# Residential Re-Development Land off Bradford Road, Cleckheaton

## Surface Water Drainage - Clarification

<b>Document prepared by:</b>	Kevin Tilford BSc MSc PhD MBA MCIWEM C.WEM CEnv
<b>Position:</b>	Director, Weetwood Services Ltd.
<b>Date:</b>	28 November 2014
<b>Version:</b>	Final v1.0

**Figure 1 – Site Drainage Layout**

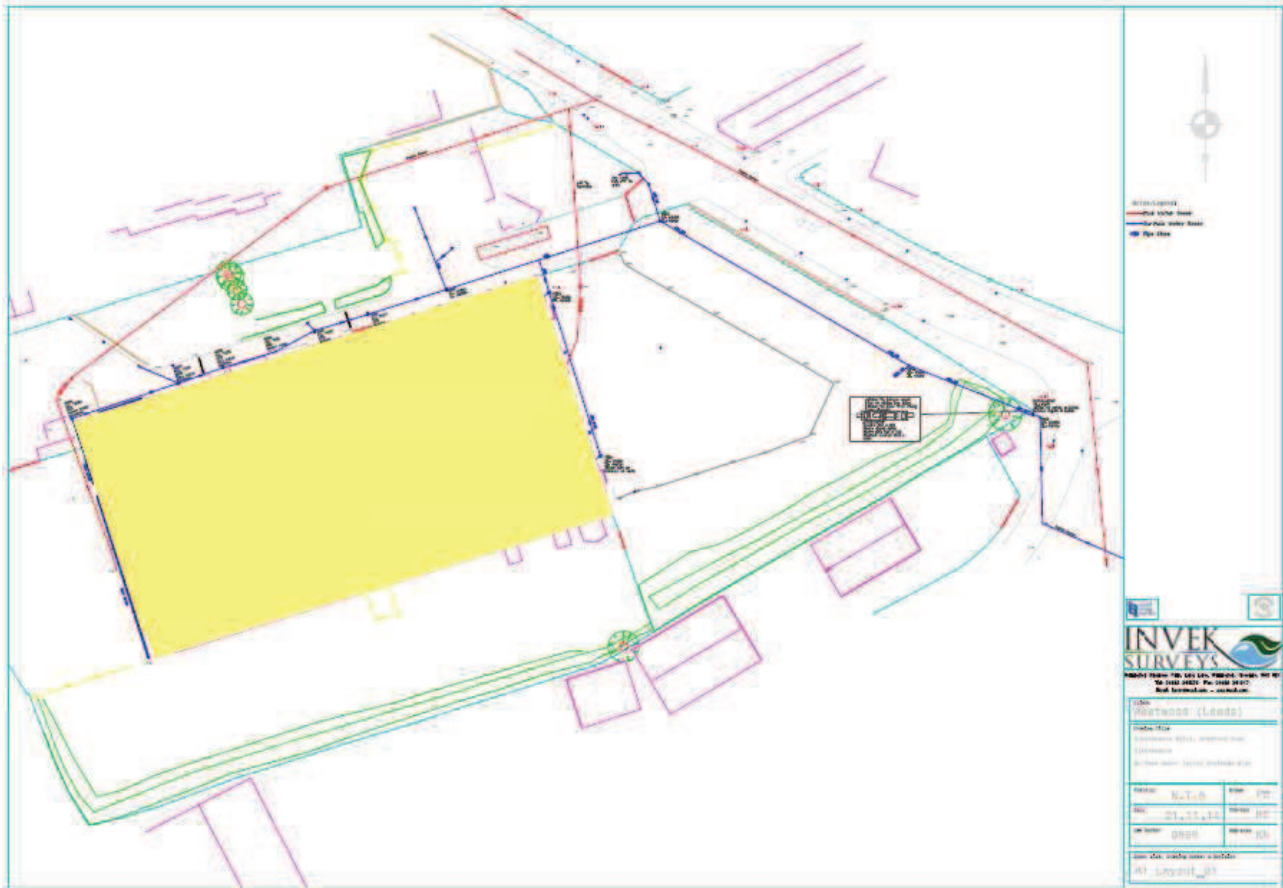
*will need to be justified in any scheme, and this will include firm topographical evidence of gullies draining hard standing.*

*A desk top study shows an area used as a car wash does not appear to be positively drained, also other yard areas may drain into soft landscaping areas so may not form part of the attenuation scheme. This information should be submitted as part of the FRA so it can be verified on site prior to setting appropriate conditions.*

10. A drainage survey of the site was undertaken by an independent drainage contractor (Invek Surveys Ltd) on 20 November 2014. The information provided by the drainage survey supercedes the information provided in the FRA report.
11. The site drainage layout based on the drainage survey is presented in **Figure 1** and the findings of the drainage survey are summarised below:
  - 62% (1.66 ha) of the site is impermeable and 38% (1.01 ha) is permeable.
  - Surface water from the impermeable surfaces drains via a 450 mm diameter concrete surface water sewer
  - Although not all manholes could be lifted, the 450 mm sewer receives inflows from a number of smaller diameter surface water sewer pipes draining the impermeable

surfaces of the site including the car wash facility located on the north-eastern corner of the site.

- The 450 mm concrete sewer outfalls to a 3 chamber interceptor tank located on the eastern edge of the site.
- The interceptor tank outfall is by way of a 450 mm diameter sewer. This sewer connects into the public surface water sewer at a manhole located in Rawfolds Way (see **Figure 2**).
- The public surface water sewer in Rawfolds Way discharges into Spen River via a 750 mm diameter sewer pipe.
- There is no evidence of an existing attenuation tank or hydrobrake style outlet control on site.

**Figure 2 – Connection of Site Surface Water Drainage to Public Sewer Network**

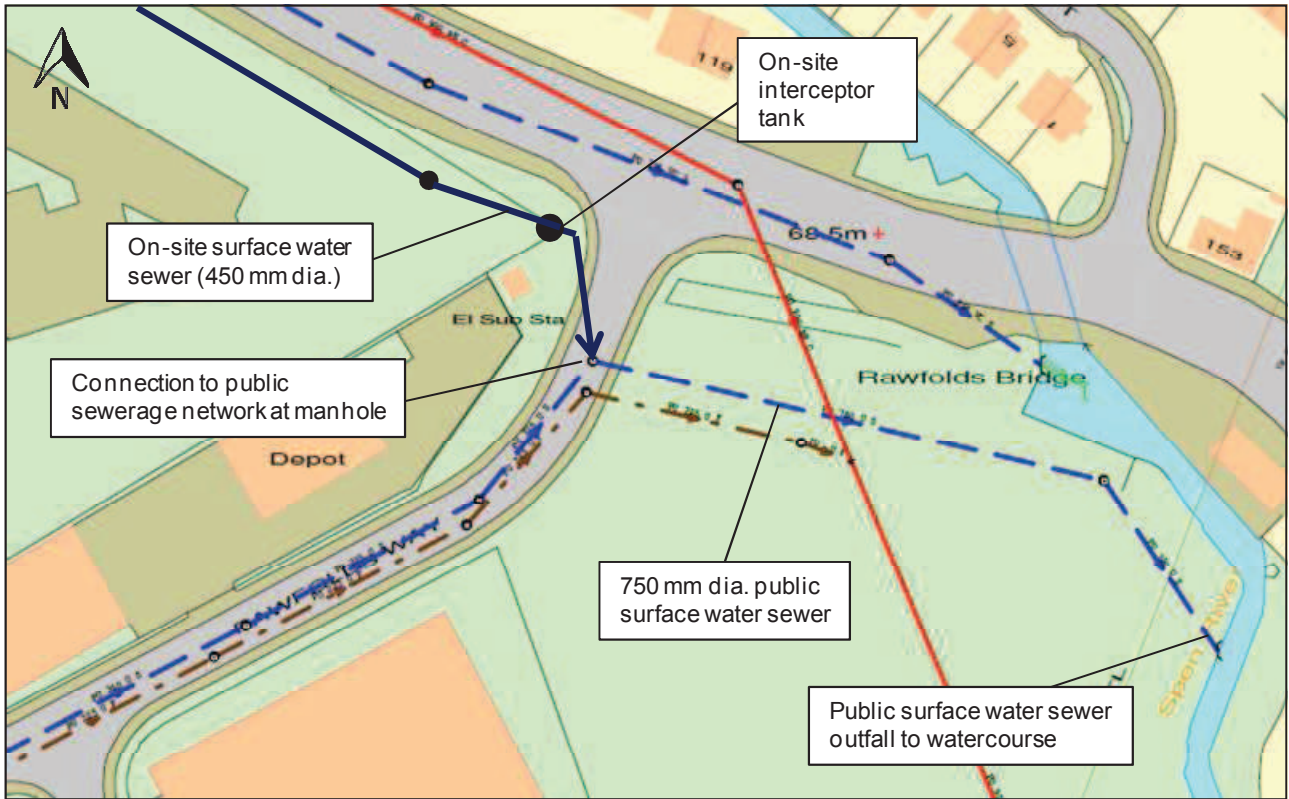
*If this is evidenced we would have no objection to a 30% reduction of discharge which is in line with Kirklees guidelines. The use of any existing attenuation tank and its location*
